July 29, 2016

Re: Drainage Control Ordinance (14-5-2-1) and NPDES CGP Violations for Erosion and Sediment Control – Indian Ridge Townhomes

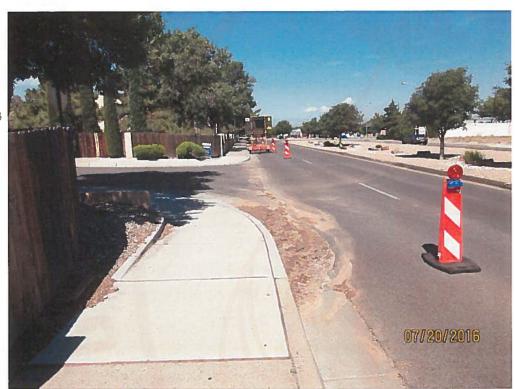
Sediment in Menaul Blvd and water introduced by contractor 7-20-16.

- 1. Sweep Menaul Blvd from the west curb return at Deanna St. up to the east edge of the project.
- New Mexico 87103
- 2. Provide a sediment BMP (wattle/mulch sock) downstream of the dirt piles. The dirt piles could be removed from Menaul Blvd as an option.

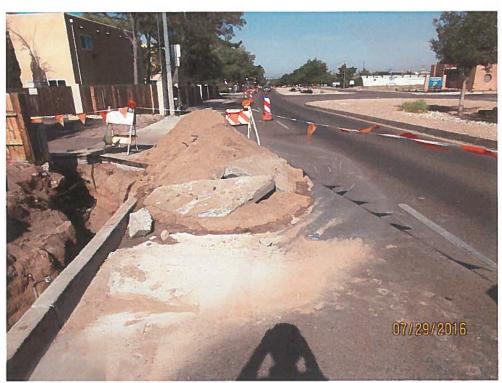
Sediment at Deanna St. 7-20-16

PO Box 1293 Sediment in Menaul Blvd. Pile at Deanna St in the distance.

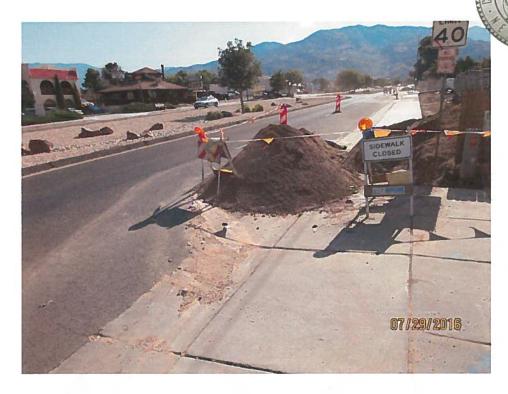
Flow introduced by contractor transporting sediment downstream.

No sediment BMP downstream of dirt pile.
